**PROJECT NAME:** Spruce Peak Bridge

**DRAWING TITLE:** ERECTION DRAWINGS - PLANS

Drawn By: JR	Verified By: AC	<b>GDF-1</b>
Project no.:	1415-032-U // G-40856

**Vermont Agency of Transportation RECEIVED**

**A BRIDGE FRAMING PLAN**  
SCALE: 1/8" = 1'-0"

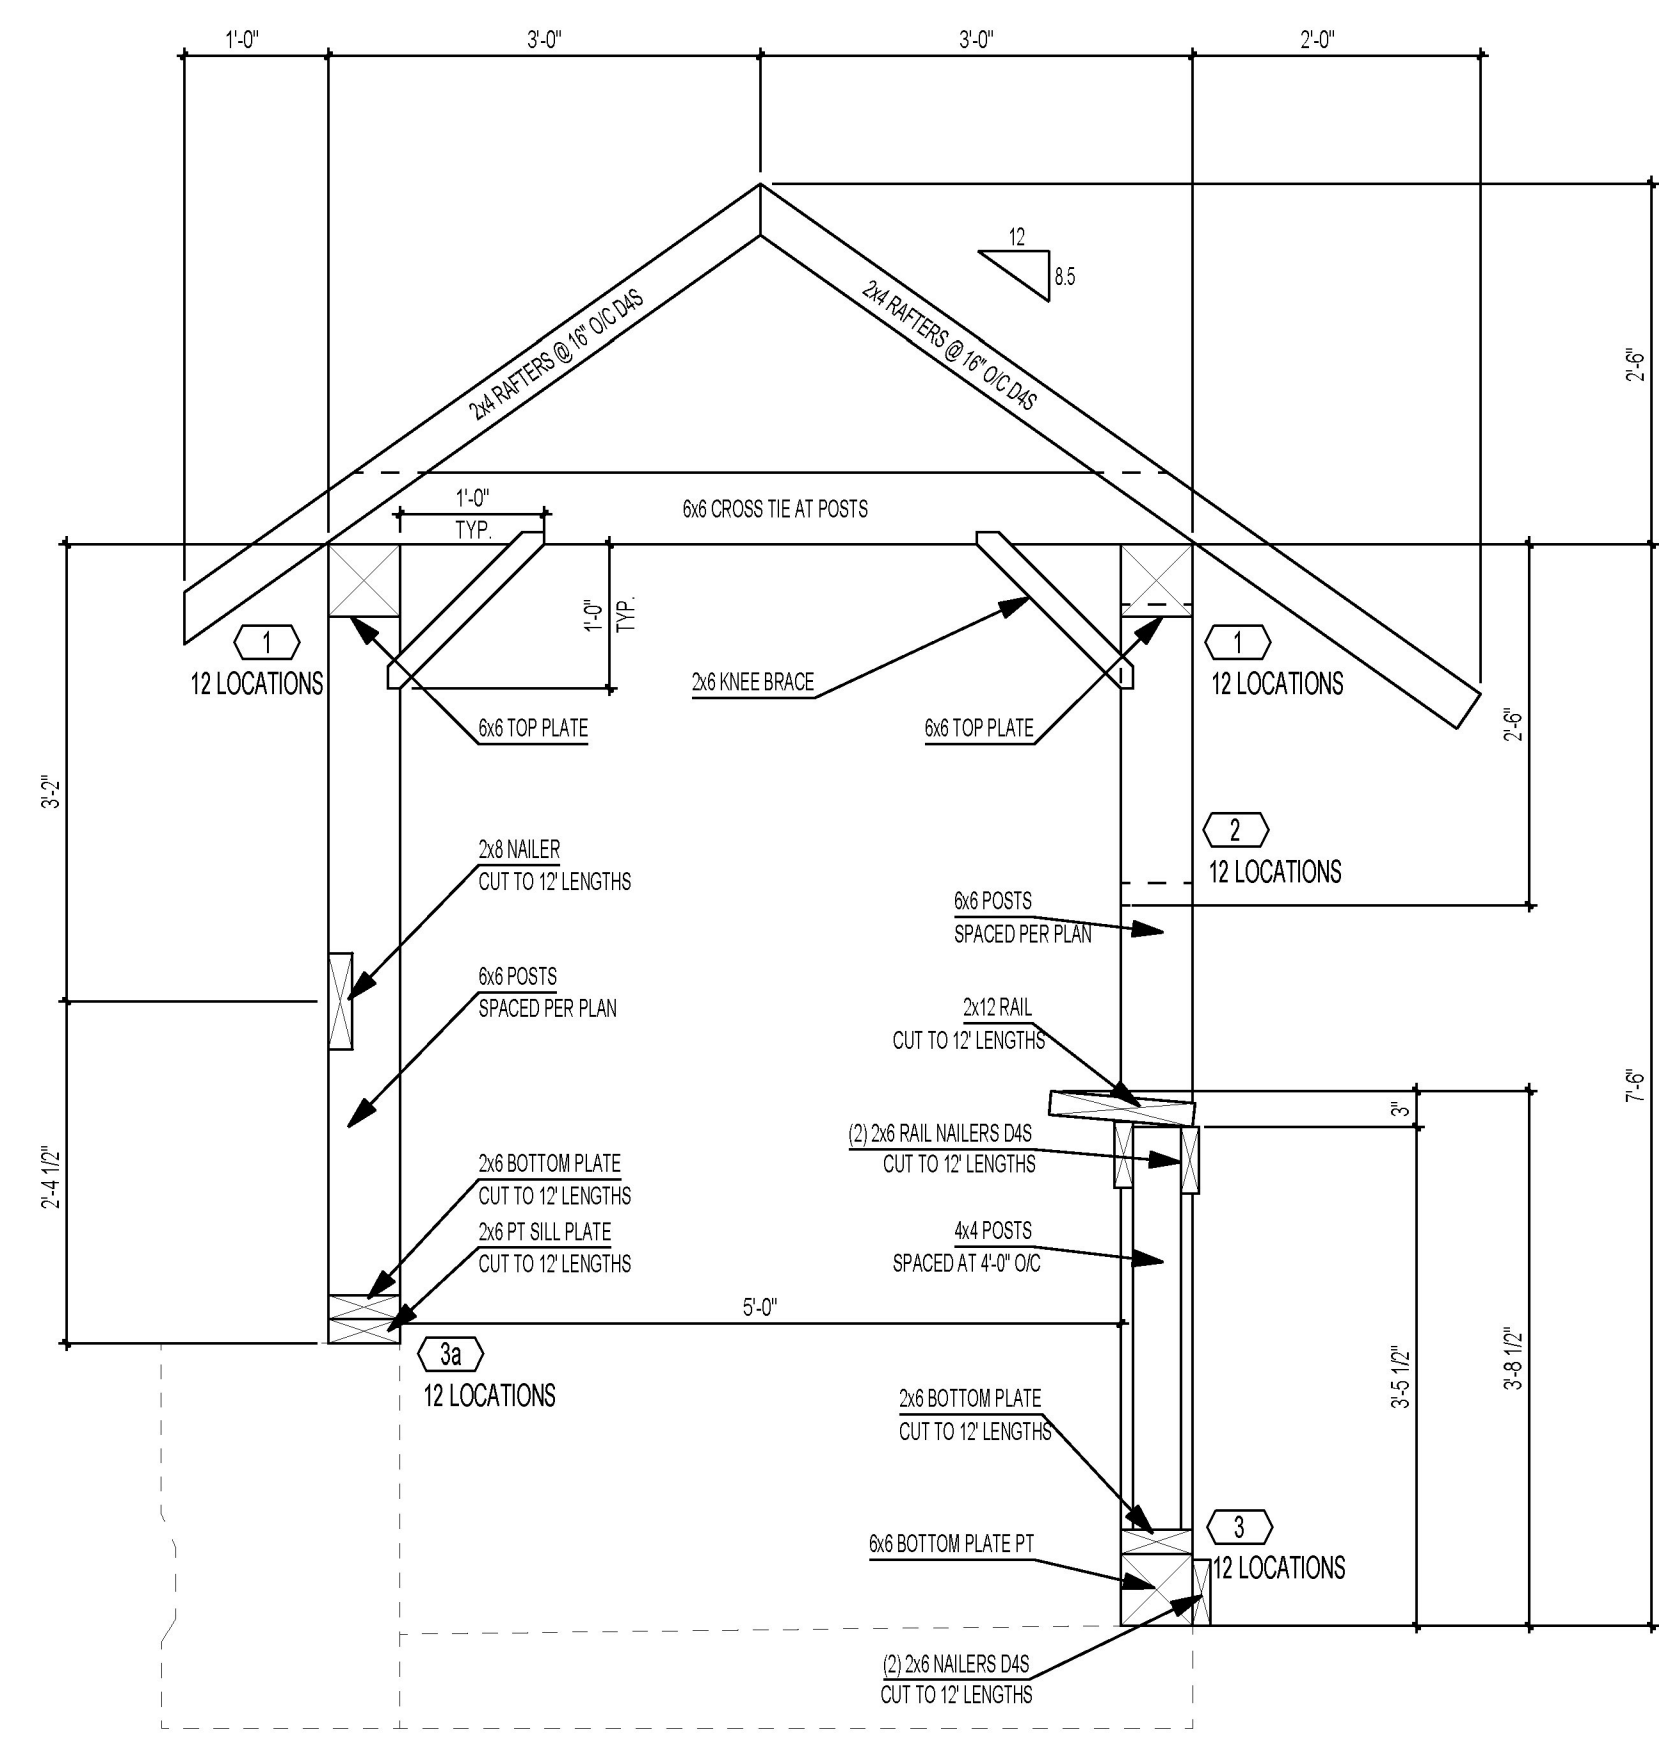
We want to remind supplier/fabricator that All steel brackets, angles, and hardware needs to meet Vtrans certification requirements and the requirements of buy america.

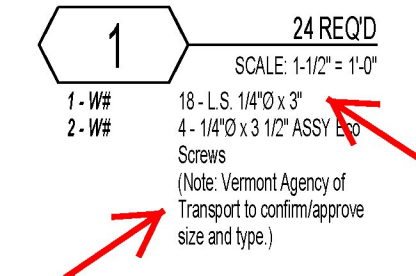
Please provide more information regarding screws like cut sheets showing the material, coating, and whether it meets Buy America.

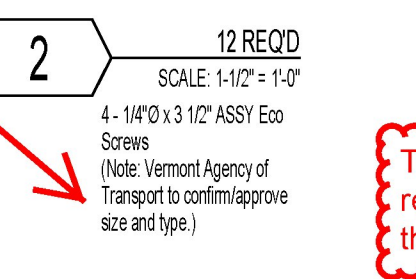
Please verify 18 bolts. It seems like there should be 20.

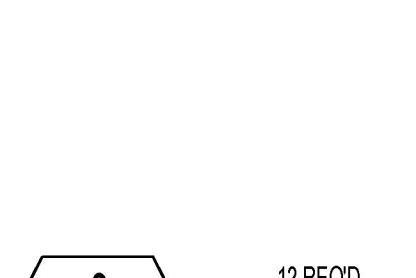
There should be 2 screws at each of knee brace resulting 4 total screws per knee brace. Therefore for this detail there should be a grand total of 8 screws
